**4294A-05C**

**S E R V I C E N O T E**

## Agilent 4294A Precision Impedance Analyzer

**Part Number Changes for LCD and LCD Assemblies with backlight lamp  
change recommendation**

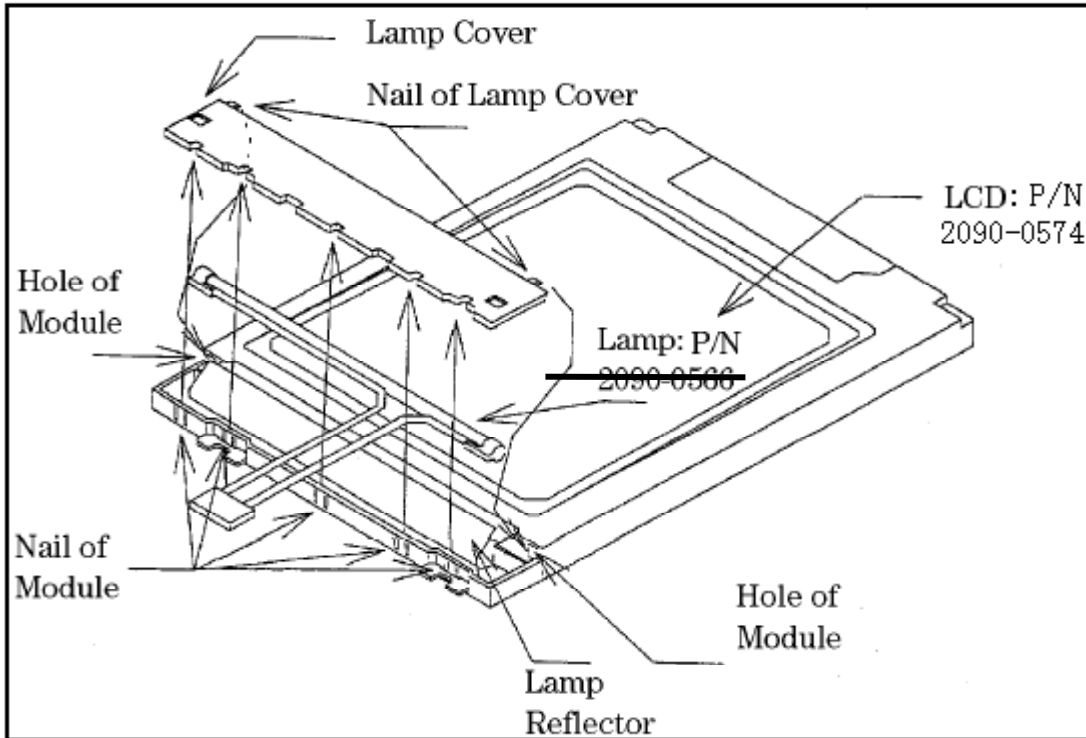
Replace whole OLD LCD units

Part Number	Qty	Description
5185-3731*1	1	A52 LCD 8.5 inch
0950-2924	1	A54 Inverter
04294-04001	1	Cover
E4970-25002	1	Insulator
04294-61620	1	Cable
04294-00603	1	Case Shield
04294-60001	1	Chassis

\*1: Refer to the above "Situation" part, and change only a lamp (2090-0566) if it is burned-out.

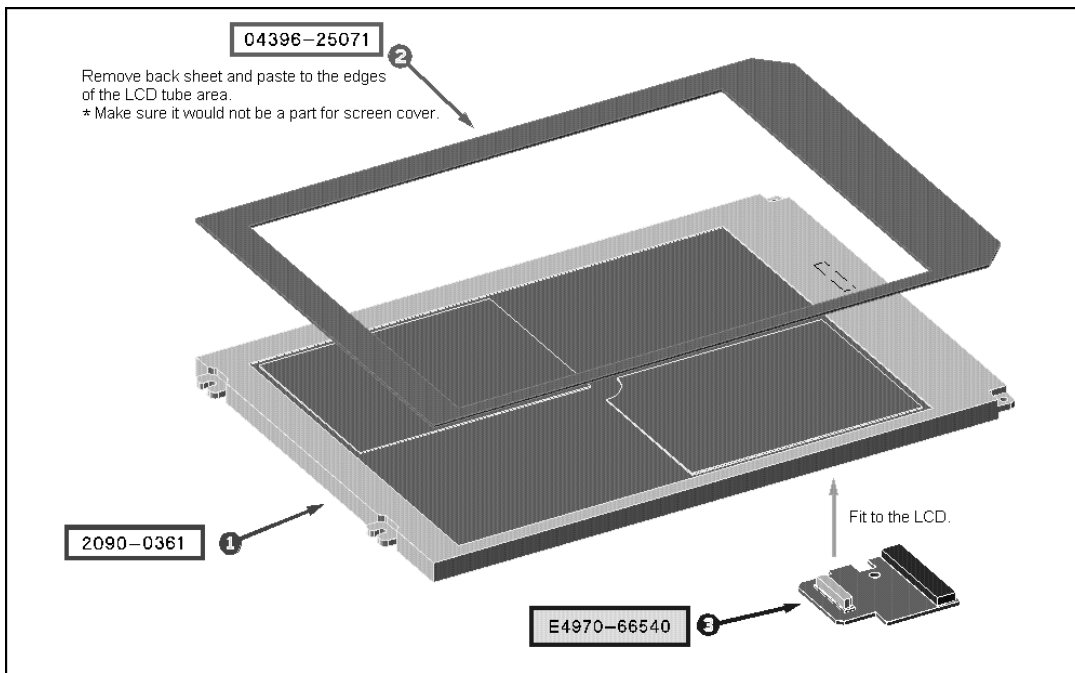
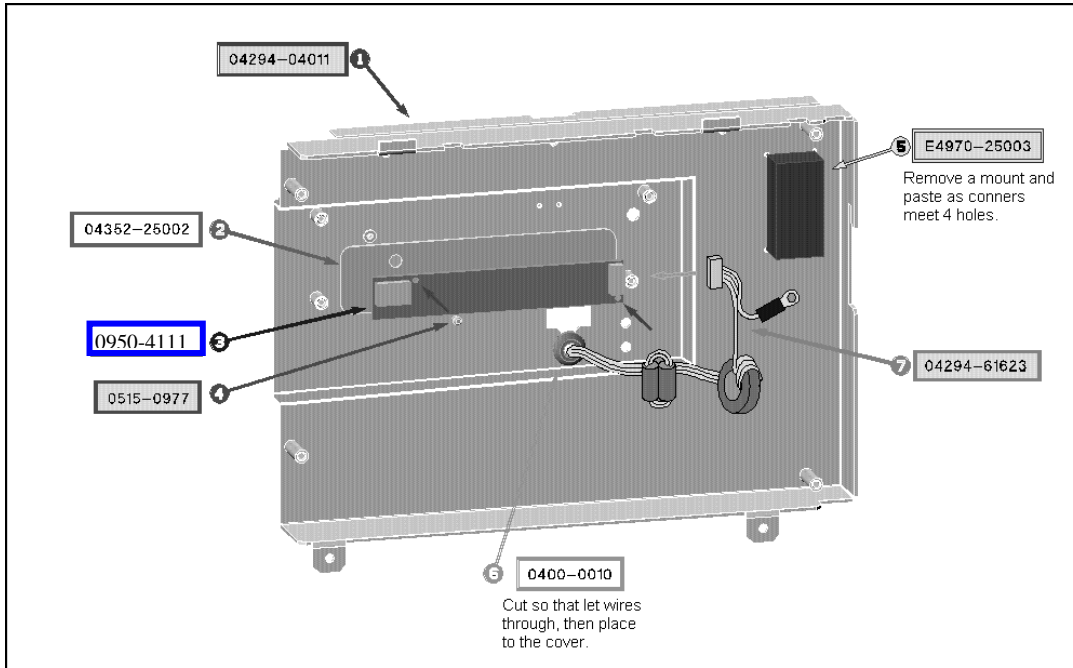
When replacing the backlight lamp in the old LCD, remove the lamp and install new one as illustrated in the following figure.

2090-0566 was replaced by 5188-1640.
